ADDENDUM NO. 2

DATE: May 21, 2020
TO: ALL PLAN HOLDERS OF THE:
2020 PAVEMENT RESURFACING PROJECT
FROM: LYNETTE KONG – CITY OF MORGAN HILL
SUBJECT: CHANGES & CLARIFICATIONS

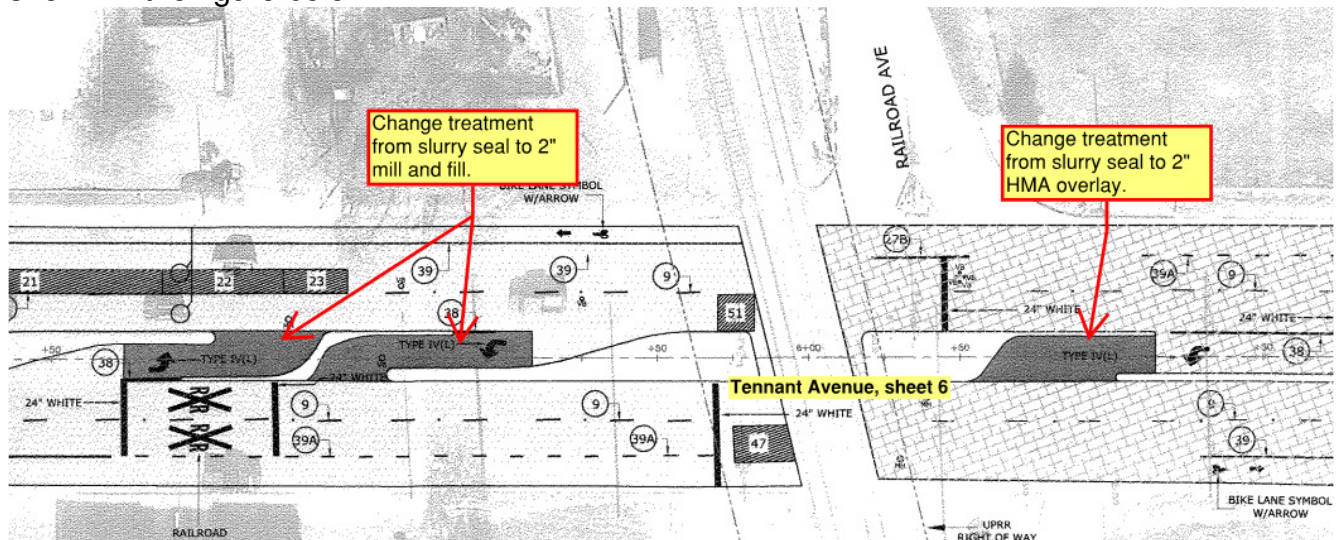
- 4) **Construction Plans, sheet 6 “Tennant Avenue, Vineyard Boulevard to Ant Court”:** The paving treatments for the three left turn pockets along Tennant Avenue shall be changed from slurry seal to the adjacent paving rehabilitation treatment as shown in the figure below.
